SUNDRY NOTICES AND REPORTS ON WELLS

Southland #4

SOUTHLAND 4
Plug and Abandonment Procedure

CONDITIONS OF APPROVAL

Wellbore Schematic

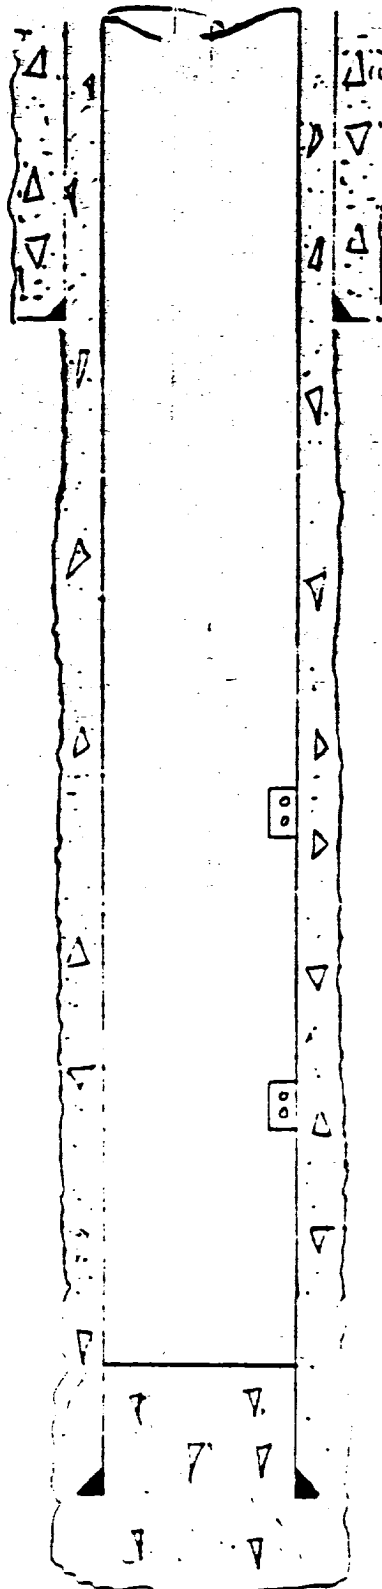
-
- 1.) MIRU cement company to ^{1 1/4" tubing} ~~2-7/8" casing~~. Establish pump-in rate. Mix and pump 50 sx neat "G" to fill up casing from top to bottom.
- 3.) Cut off wellhead. Install P&A marker. Reclaim location.

You are required to use tubing to plug the subject well due to questionable casing integrity encountered during recent workovers.
